Discharge of Conditions - HGY/2020/0590

23-23A High Street

9. N°19 Further Energy Statement

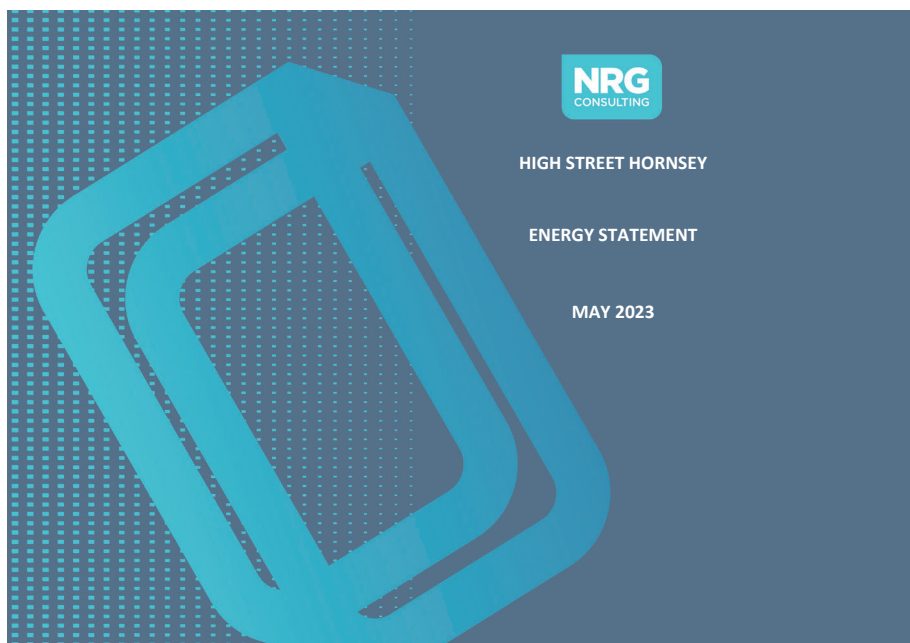
The applicant has revised the energy statement which now shows an overall 68.89% (72.58% as reported, which is an error) carbon reduction through the development with SAP10.2 carbon factors. However, the proposed building fabric parameters still results in higher carbon emission than the baseline, which is not policy compliant. This goes against the Energy Hierarchy and requirement to take a fabric first approach in line with London Plan Policy 5.2, 5.3 and Local Plan Policy SP4.

Also, the cooling demand is almost 3 times higher than the notional figures which is not accepted. The applicant should provide a commentary on why the cooling demand is so high and explore measures to minimise this as much as possible.

1. Improve the fabric efficiency in line with the fabric first approach.
2. Submit GLA's Carbon Emission Reporting Spreadsheet.
3. Submit SAP sheets for representative selection of the development for the Baseline, Be Lean and Be Green scenarios.
4. Please provide a commentary on this and provide mitigation measure to reduce the cooling demand as much as possible.
5. Please identify on a plan where the VRF units will be located within the commercial units.
6. It is recommended to make use of solar PV that can further reduce the on-site emissions and comply with Local Plan Policy SP4: 20% carbon reduction with renewable energy generation on-site.
7. How will the ASHP units be mitigated in terms of visual and noise impact.
8. How much of the heating/hot water demand will be met by the proposed type of heat pump? If this cannot be met fully, how will this be supplemented?

In response to further clarification sought by the LPA in an email received on the 25th of January 2024, additional information has been inserted into the revised Energy Statement. We have responded to their remaining comments (points 5 and 7) accordingly:

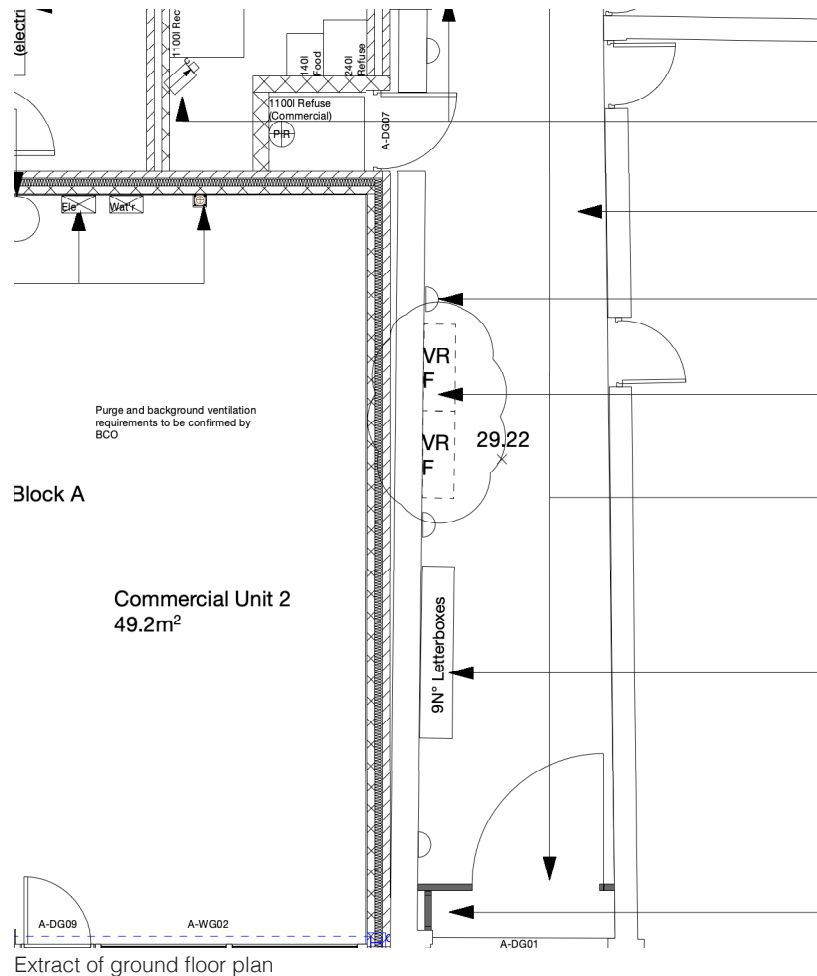
“5. Please identify on a plan where the VRF units will be located within the commercial units”.

The VRF units for the commercial units will be located within the existing under-croft at high-level.
